In the Matter of)
)
PACIFIC GAS AND ELECTRIC COMPANY)
)
(Diablo Canyon Nuclear Power)
Plant, Units 1 and 2)

TESTIMONY OF DR. ENRIQUE LUCO

Comments by

In compliance with the order of the Atomic Safety and Licensing Appeal Board (August 7, 1980, ALAB-640), I have reviewed the testimony offered by the parties and have considered the questions raised by the Board. My comments to the first six questions are included herewith.

Fig. 1-1
(Luco)

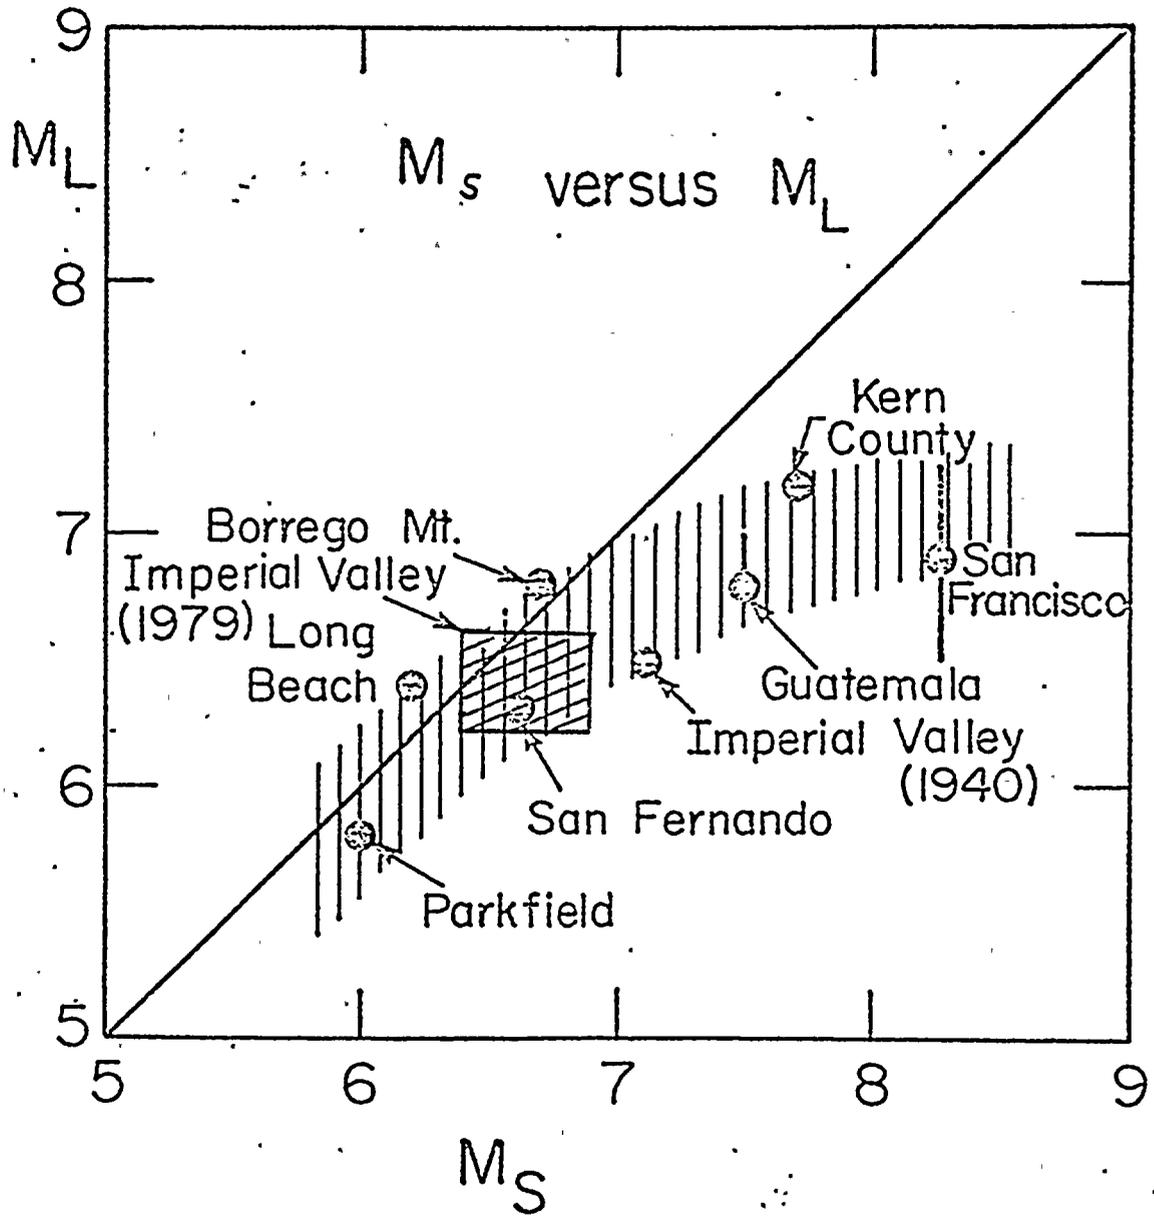
The relation of the IV79 event to other California earthquakes (and to the Guatemala earthquake) is shown in Fig. 1-1. This figure taken from the work of Kanamori (Bull. Seism. Soc. Am. 69, pp. 1645-1670, 1979) has been modified by superimposing the possible region of (M_L , M_S) values for the IV79 event. This figure indicates that given M_S there is a considerable range in the possible values of M_L .

For the Hosgri $M_S = 7.5$ event, the local magnitude M_L could vary from a value of about 6.6 to a value of 7.2. The implication of this is that given a magnitude $M_S = 7.5$ the peak response of a structure with a period of 0.8 sec (1.25 Hz) and 80 percent damping could vary by a factor of 4. For a structure with lower damping and shorter period (higher frequency) the margin of possibilities is larger still. This example underscores the uncertainties associated with prediction of high frequency components of motion. In the range of local magnitude from

Figure 1-4
(Luco)

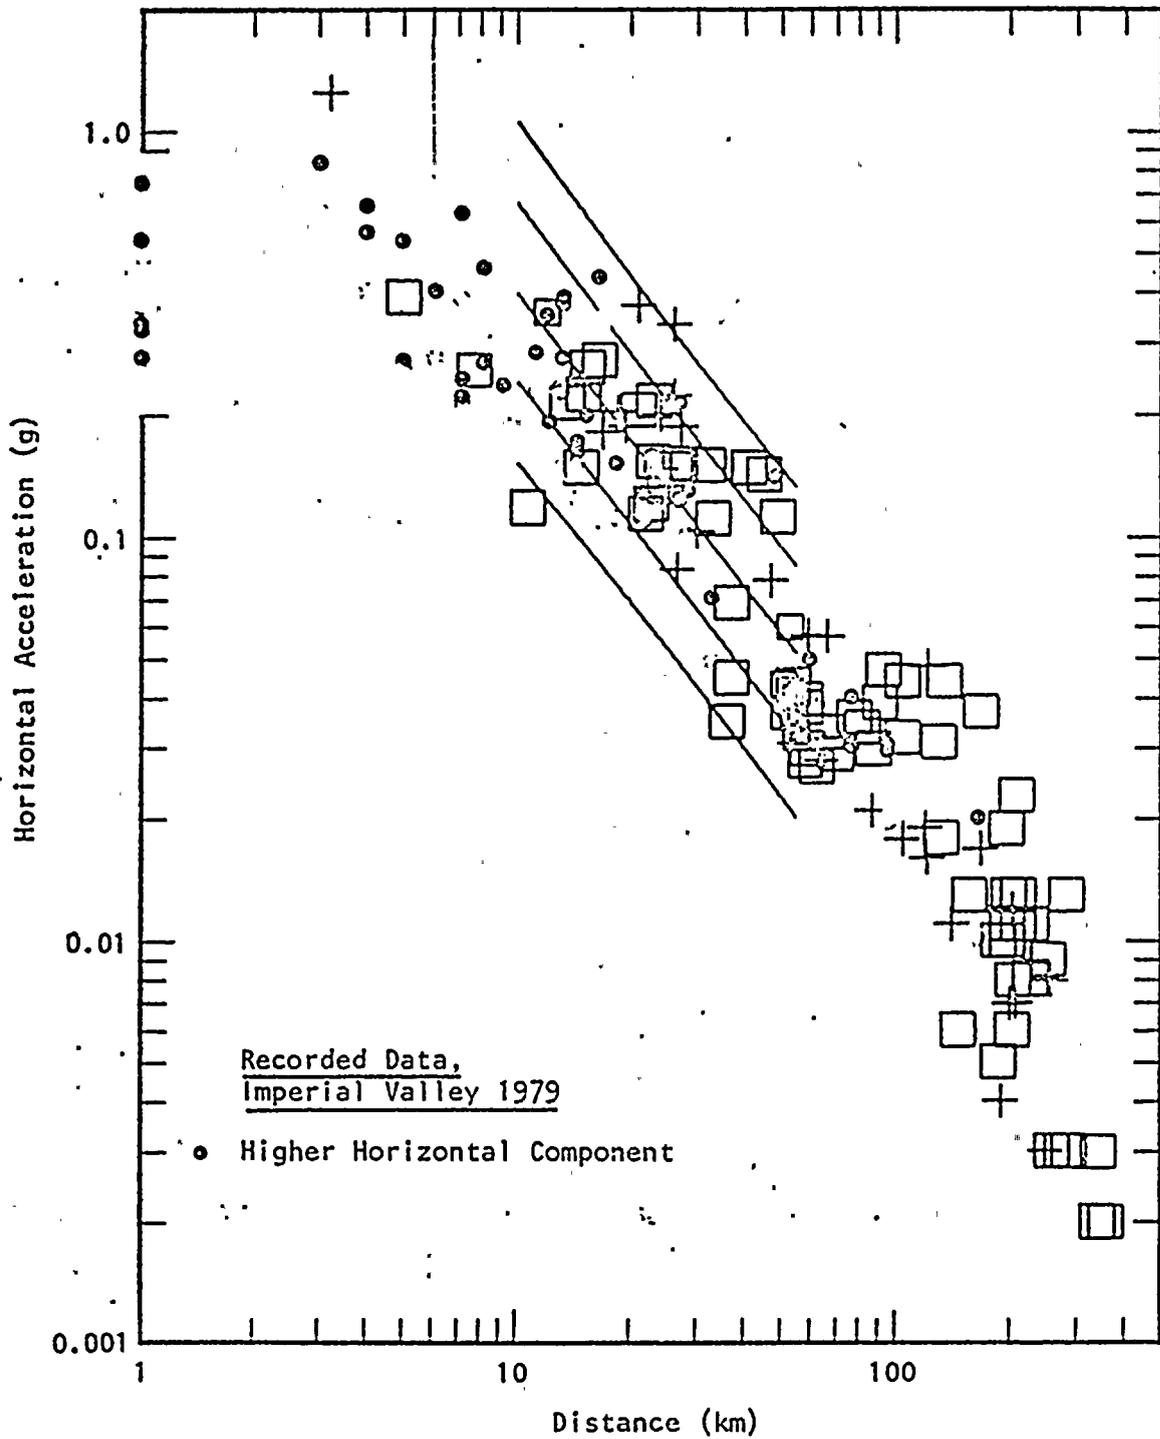
Inspection of Fig. 1-4 reveals that for distances to the fault larger than 10 km, the IV79 horizontal accelerations are not different from accelerations recorded during previous earthquakes in the magnitude range M_L 6.0 - 6.4. In this distance range, only two IV79 data points fall outside the 70 percent confidence limits of Circular 795 and all of the IV79 data points fall within the 95 percent confidence limits.

In the distance range from 3 to 10 km, the trend of the IV79 data points is somewhat higher than that defined by the records 824 Orion (0.258g, 7.7 km, San Fernando) and Esso refinery (0.39g, 5 km, Managua) and somewhat lower than the peak acceleration at Pacoima Dam (1.25g, 3.2 km, San Fernando). The attenuation

of peak acceleration with distance in the range from 3-10 km seems to be lower than that from 10 to 100 km.

Fig. 1-4 indicates that the average peak acceleration for stations within 1 km from the fault is somewhat lower than the accelerations recorded 3-4 km from the fault as previously discussed.

Figure 1-5.
(Luco)

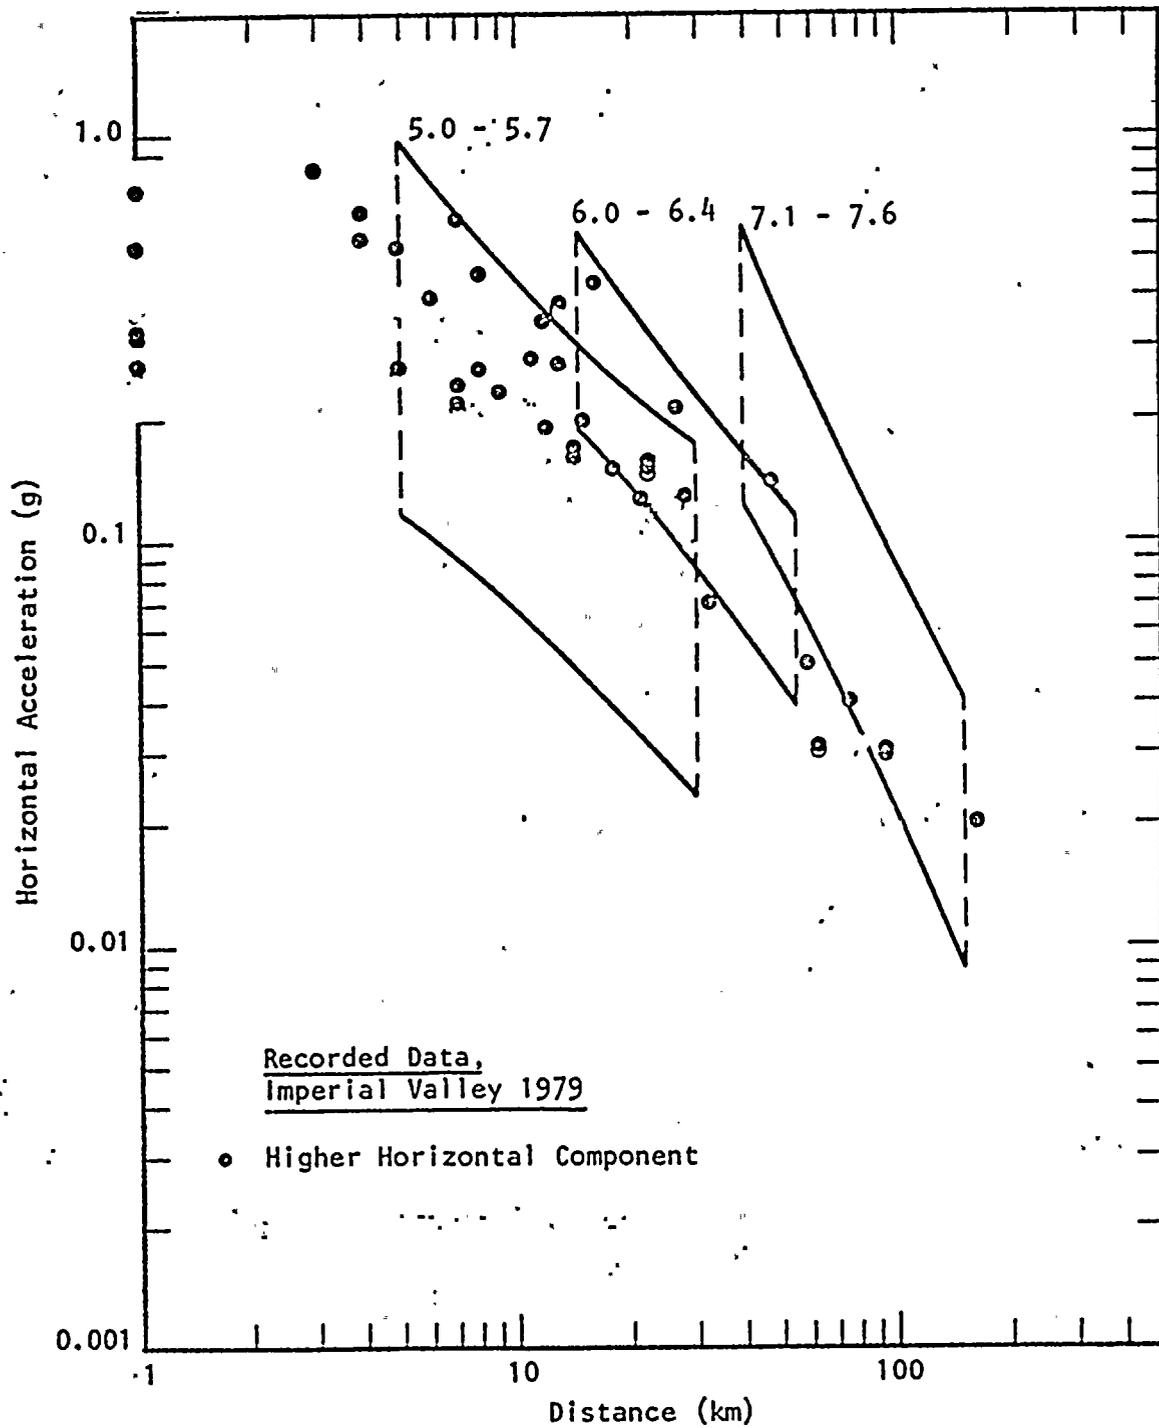
Figure 1-5 shows the comparison of the recorded IV79 peak horizontal accelerations with the 70 percent prediction intervals of USGS 795 for the magnitude ranges 5.0-5.7, 6.0-6.4 and 7.1-7.6. The data and the confidence intervals are plotted versus distance to the fault. Fig. 1-5 corresponds to Fig. I-6 of Blume's testimony except that for consistency with the criterium of USGS 795, only the largest peak acceleration at each station has been considered.

In the distance range from 40 to 150 km the IV79 data points fall close to the lower limit of the 70 percent interval for magnitudes 7.1-7.6 indicating that in this distance range peak acceleration increases with magnitude. In the distance range from 15 to 40 km, the IV79 data points fall within or close to the 70 percent interval for magnitudes 6.0-6.4 indicating that the IV79 earthquake is not different from other earthquakes in the magnitude range 6.0-6.4. Finally, in the distance range from 5 to 30 km the IV79 peak accelerations fall in the upper half of the 70 percent confident limit for the magnitude range 5.0-5.7 indicating that peak acceleration increases with magnitude in this distance range.

The comparison shown in Fig. 1-5 indicates that peak acceleration increases with magnitude in both the distance ranges of 5 to 30 km and 40 to 150 km.

Figure 2-1
(LUCO)

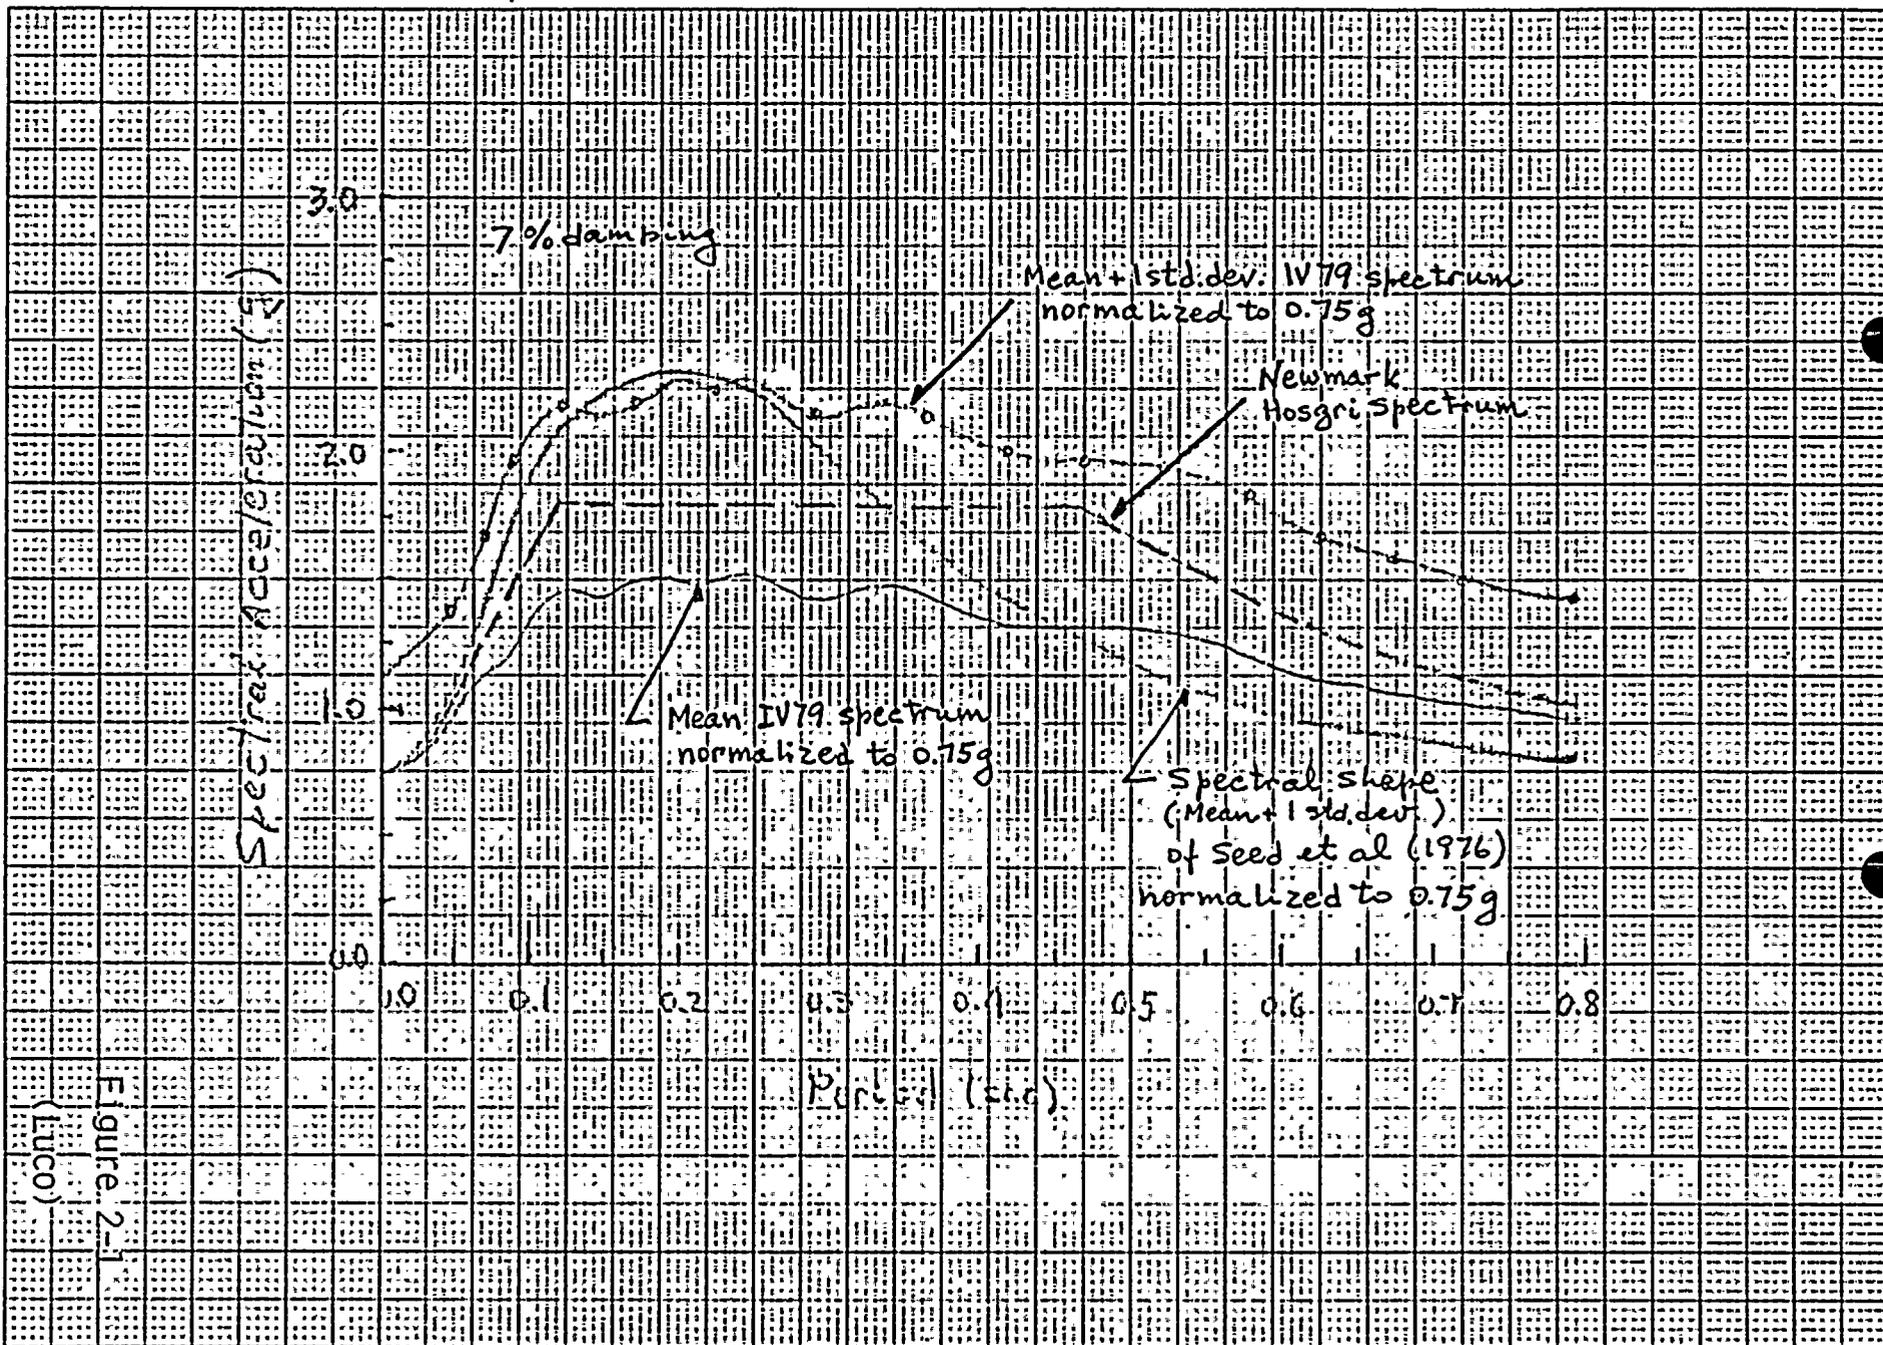
Inspection of Fig.2-1 reveals that the Newmark spectrum exceeds the average IV spectrum normalized to an expected peak acceleration of 0.75g. The Newmark spectrum falls below the corresponding mean-plus-one-standard-deviation spectrum. For periods shorter than 0.05 sec (frequencies higher than 20 Hz), the 0.75g IV mean-plus-one-standard-deviation spectrum exceeds the Newmark spectrum by 50 percent. For a period of 0.2 sec (5 Hz), the difference is of the order of 28 percent. In conclusion, the Newmark spectrum is lower than a mean-plus-one-standard-deviation spectrum based on the Imperial Valley data and a mean expected peak acceleration of 0.75g.

Figure 3-2
(Luco)

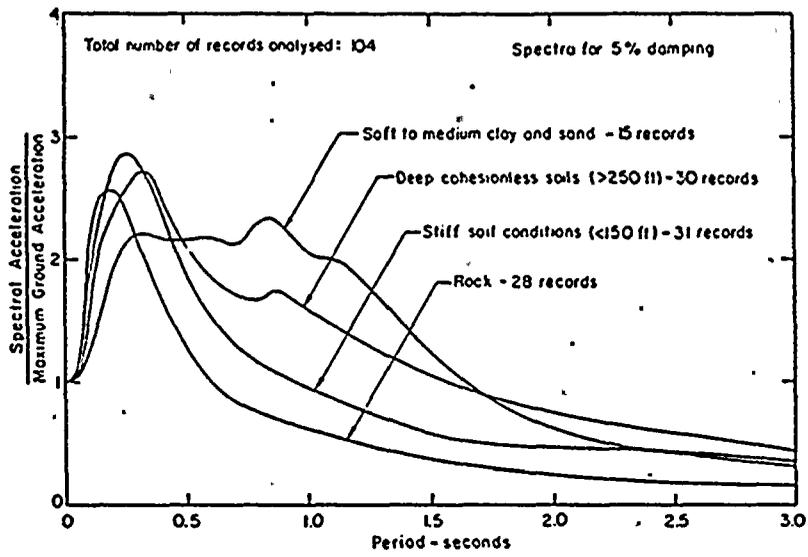
2. The effects described above also affect the high frequency portion of response spectra. Fig. 3-2, taken from a study by Seed, Ugas and Lysmer (Bull. Seism. Soc. Am., 66, pp. 221-243, 1976) illustrates this point. For frequencies higher than 2 Hz (periods shorter than 0.5 sec) the anticipated mean spectrum for rock exceeds that on deep cohesionless soils by approximately 50 percent

(M~6.5, distance of 5 miles). The results of Trifunac also indicate higher spectral amplitudes on rock than on soils for frequencies higher than 5 Hz (Jour. Engrg. Mech. Div. ASCE, Vol. 104, EM5, pp. 1081-1097, Oct. 1978).
